Field Service Bulletin No. 15

Revised August 2008

Alert and Handling Precautions - SBE 37 MicroCATs and SBE 49 FastCATs with Plastic Housing Option

Detail -- Battery end cap
SBE 37-SM, 37-SMP, 37-IM, 37-IMP

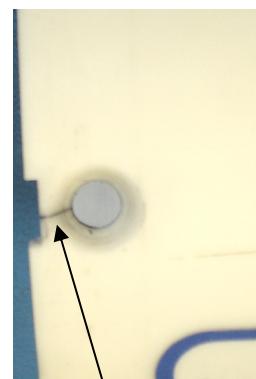
Prior to deployment / redeployment, inspect all MicroCATs (with plastic housings) for cracks around the two screw holes that retain the **battery end cap** (SBE 37-SM, -SMP, -IM, and -IMP). To check for cracking, use a magic marker and color the housing liberally around the two screw holes in the housing. When both holes have been marked, use a cloth or paper towel dipped in isopropyl alcohol to wipe the marker off of the housing's surface. If there are cracks in the housing, the marker will have wicked into the cracks, and the cracks will become visible.

**Example crack,
battery end cap side only**
(ink applied to crack to illustrate)

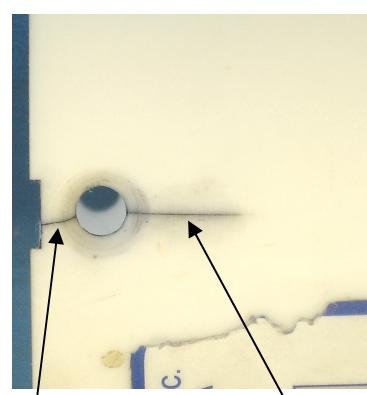
- If the ink test reveals cracking of the housing only on the **battery end cap side of the screw hole**, the MicroCAT may be deployed / redeployed as required. However, carefully adhere to the **torque specification of 15 in-lbs for the battery end cap retaining screws**. Return the MicroCAT to Sea-Bird at your earliest convenience for installation of a new housing under our standard warranty policy.

**Example cracks
battery end cap side and electronics side**
(ink applied to cracks to illustrate)

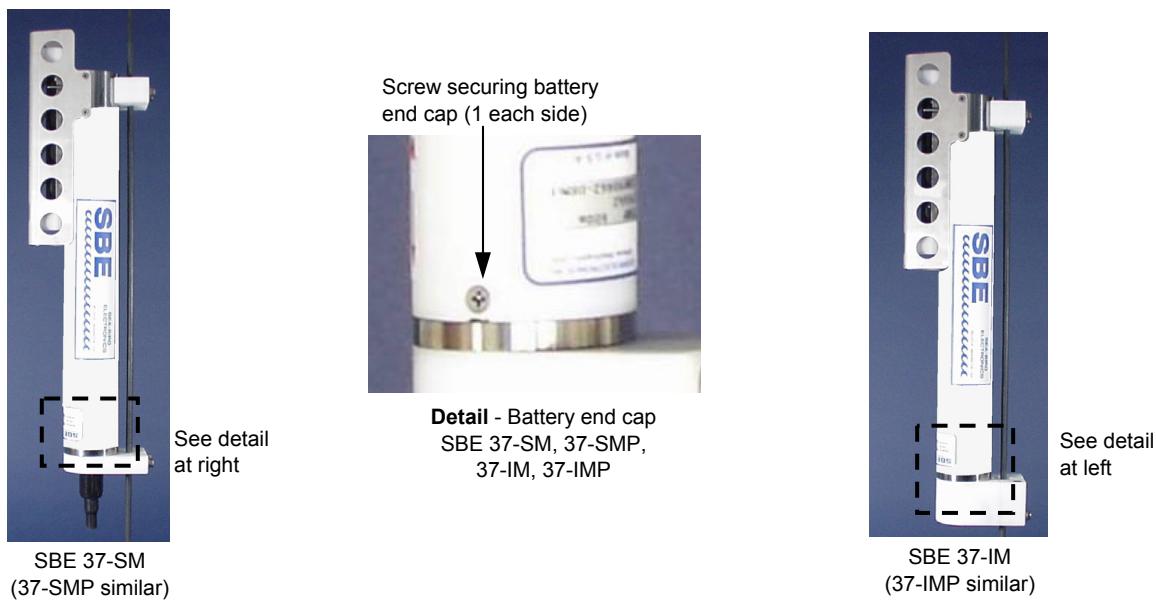
- Over-torqueing the screws can cause cracking on the **electronics side of the screw hole (away from the end cap)**; this can create a leak path past the O-rings. If the ink test reveals cracking of the housing on the **electronics side of the screw hole**, **do not deploy/redeploy the MicroCAT, as there is a high probability of flooding** of the MicroCAT. Return the MicroCAT to Sea-Bird for installation of a new housing under our standard warranty policy.
